DEPARTMENT of TRANSPORTATION

DOWEL BAR RETROFIT EVALUATION

DISTRICT 12
Orange County
Interstate 5

Contract Number: 12-093904

Figure 4. Dowel Bar Retrofit Details

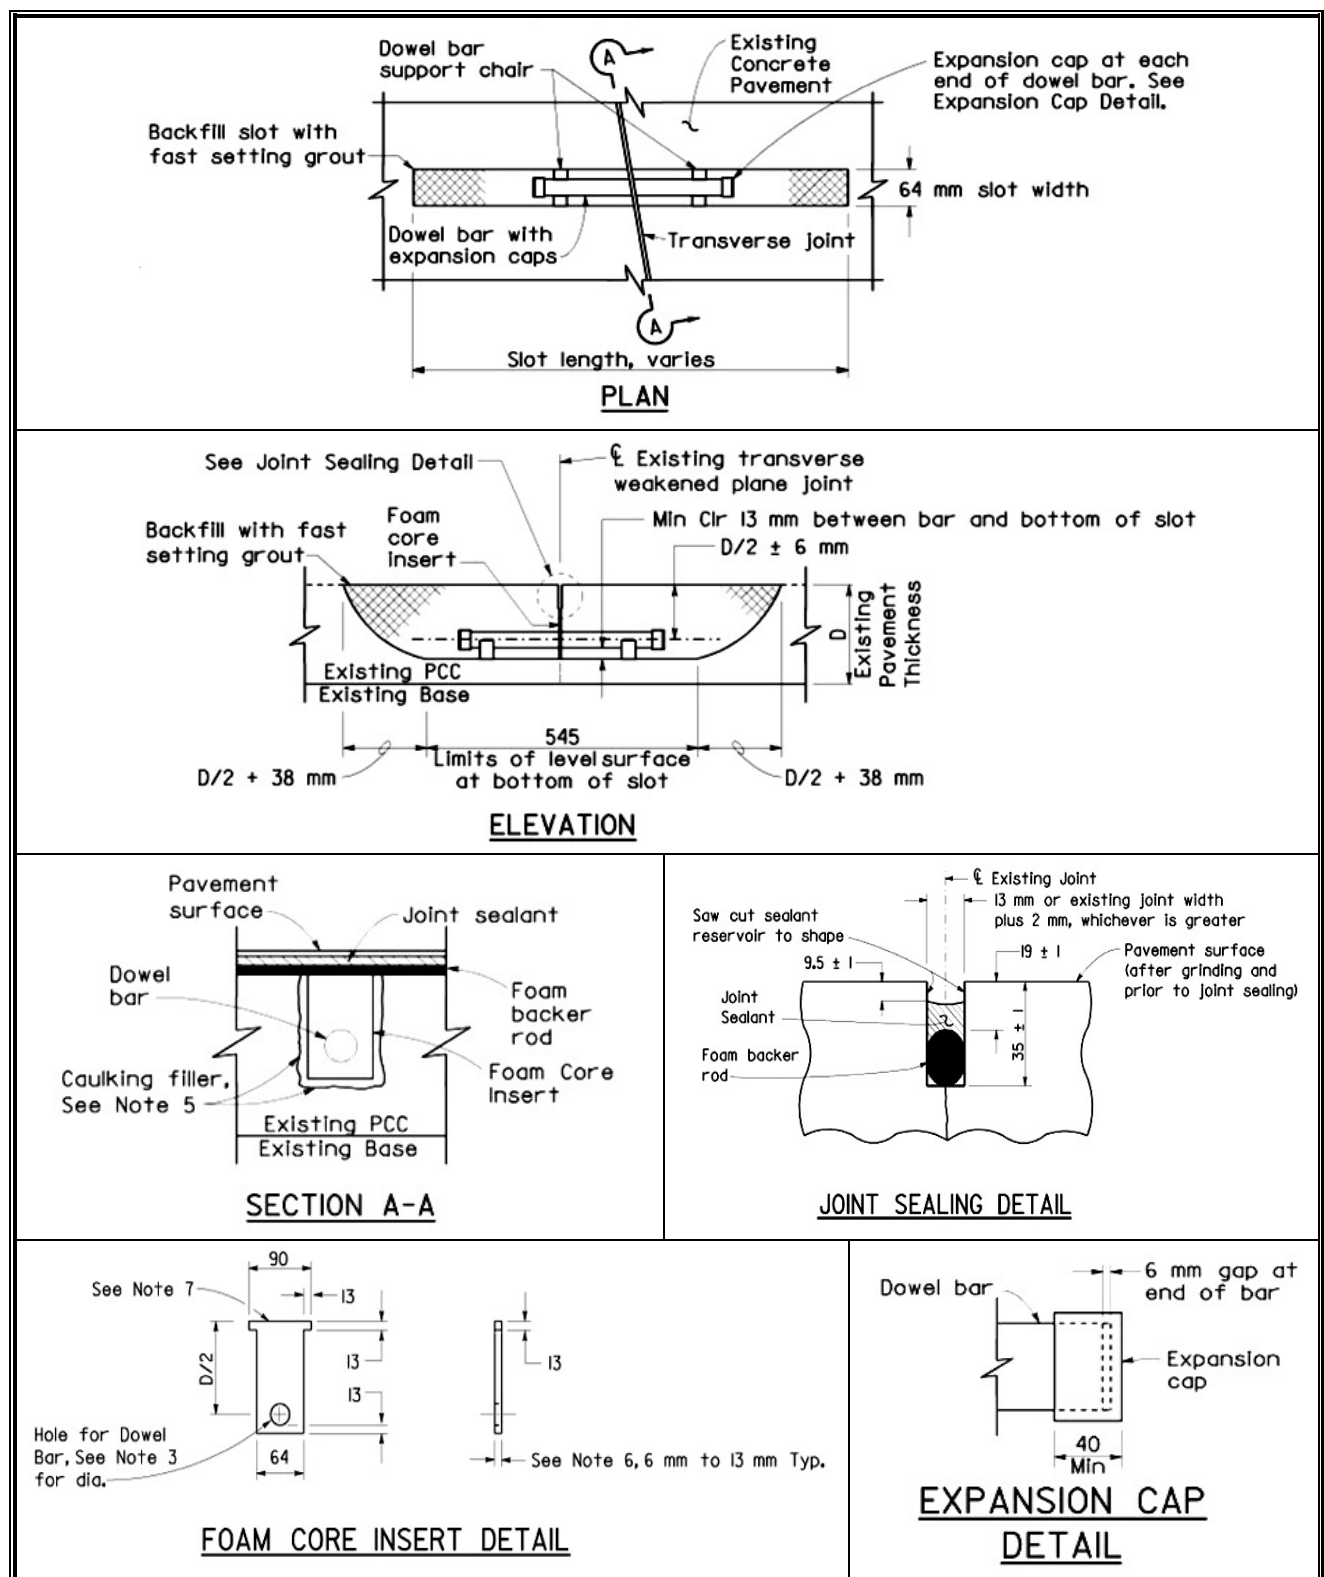
Additional measurements were made on the dowel slot depth and bar position. The measured depth of the saw cut is equal to that called for in the plans. The support chairs for the dowels, in all cases, are not resting on the bottom of the saw cuts; however, they are not so far off the saw cuts as to lift the bars out of the specified depth range. The placement of the dowels in the cores is at or just above the high limit of the required range. The plans call for the height of the chairs in the slot to be 13 mm. The chair height in the core samples were found to be 17 to 19 mm from the base of the chair to the bottom of the bar. With the chair design placing the bar 4 to 6 mm above the required depth, the slightest misalignment can easily push the dowel beyond the specified tolerance.

Two other chairs, made by separate manufacturers, were measured and found to hold a dowel 16 mm above a horizontal surface. When inserted into a tight fitting slot a bar would be lifted slightly more.

1. The chairs need to be redesigned to conform to the 13 mm specification
2. The depth of saw cut on the plans need to be redefined to meet the dimensional requirements of the support chair.

The second is the preferred because it enables maximum potential for innovation and competition, i.e. lower cost.

Figure 6. Backfill Grout

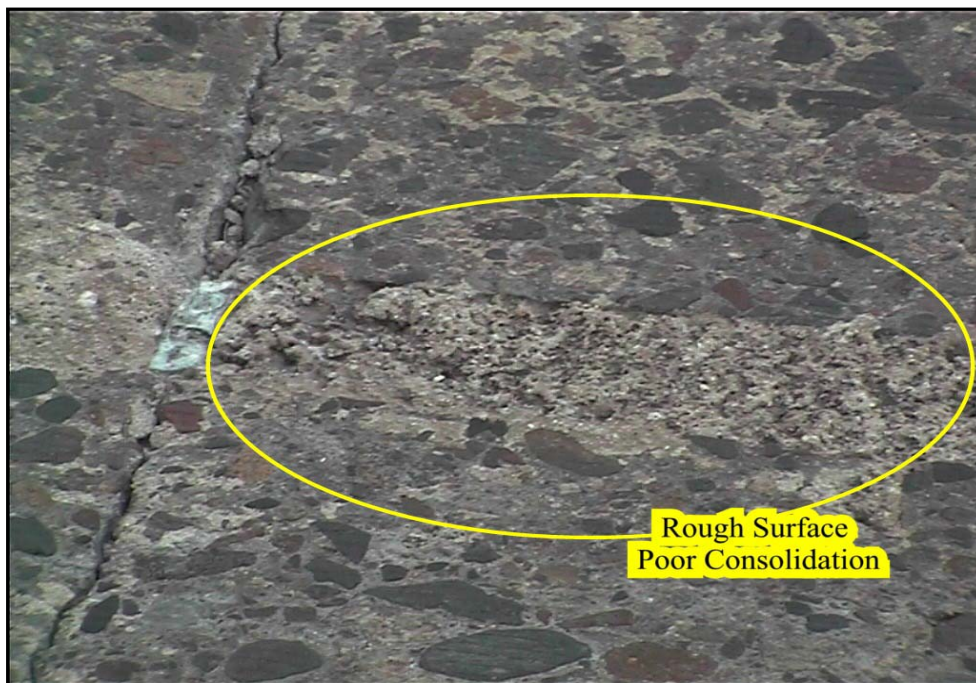
The backfill grout in some of the slots observed was between 5 mm and 10 mm above the pavement surface. The project special provisions require that the fast setting backfill grout be finished 3 ± 1 mm above the existing pavement. Some slots had a rough finish, showing poor consolidation and other flaws at the surface (Figure 6).

The surface of backfilled dowel bar slots should be rounded 3 ± 1 mm above the existing concrete surface as specified. Grout finishing that does not conform should be immediately rejected. Specifications for future projects should require that backfill material exceeding this

Figure 8. Foam Board Alignment

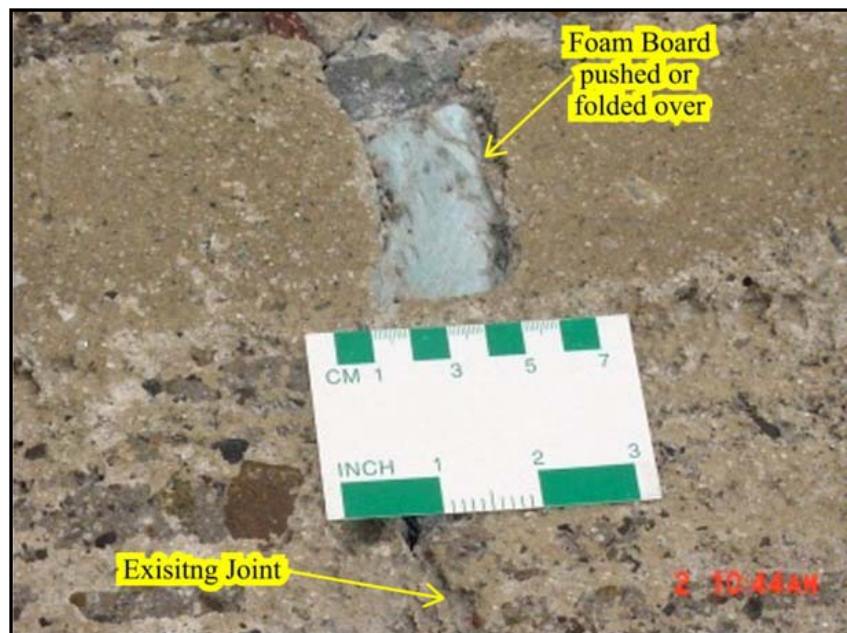
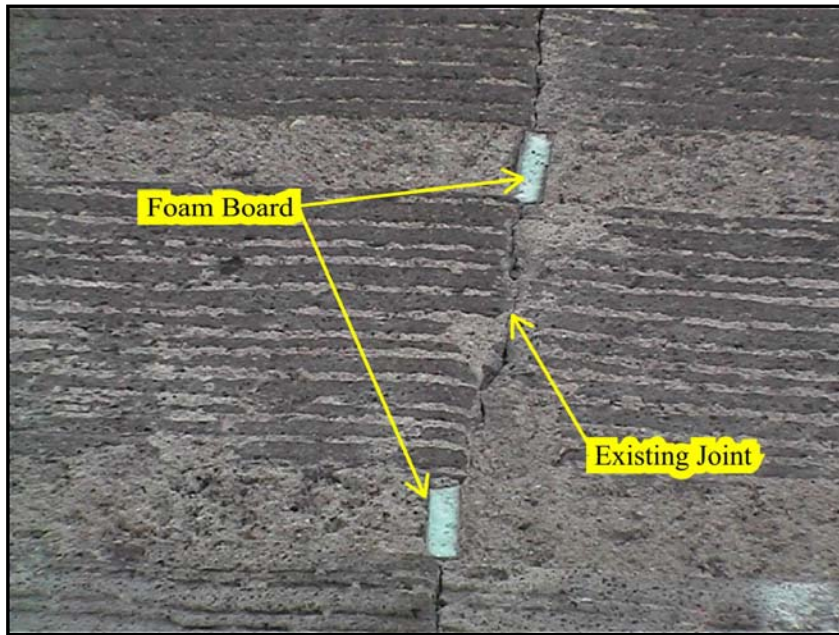
Many of the foam boards were aligned with the existing transverse joint. The foam boards are approximately 12-mm thick and seem to be adequate for maintaining the existing joint. Occasionally, the foam board was pushed or folded over at the surface; this may indicate that the dowel is not at the correct depth.

Figure 10. Ends of Dowel Bar A

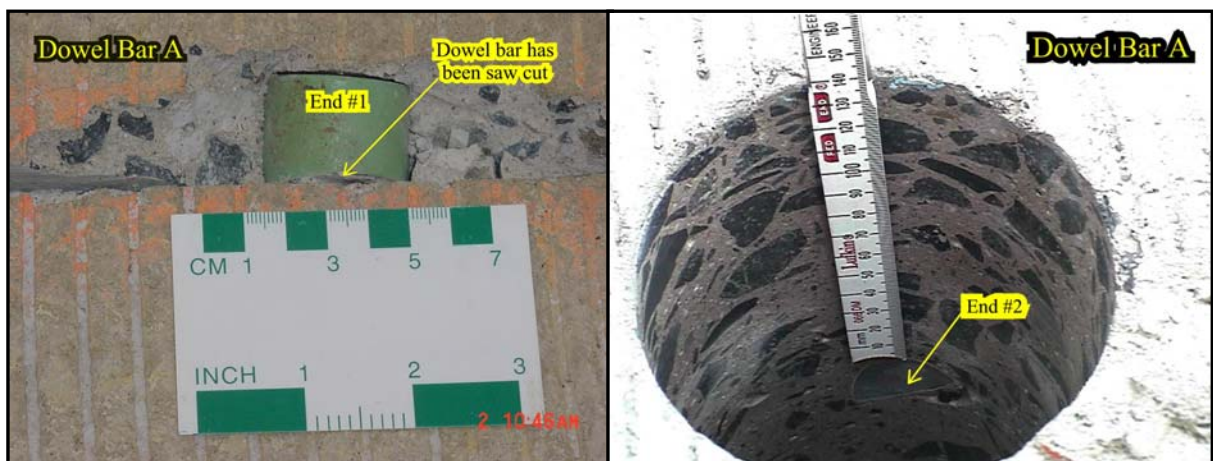
Two of the dowel bars were further examined by coring. At the first dowel bar, the embedded end was cored and found to be 140-mm below the pavement surface (Figures 9 and 10).

Figure 11. Dowel Bar B

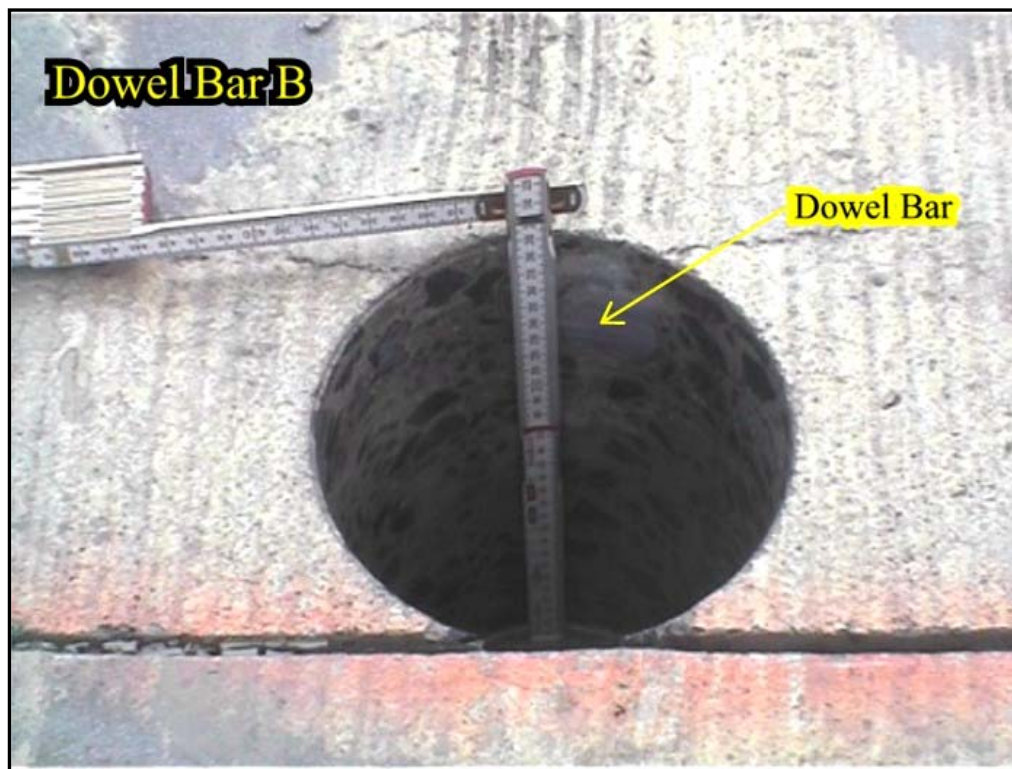
At the second dowel bar, a 150-mm core was taken at the exposed end in an attempt to capture part of the dowel bar support assembly (Figure 11). The assembly was not captured.
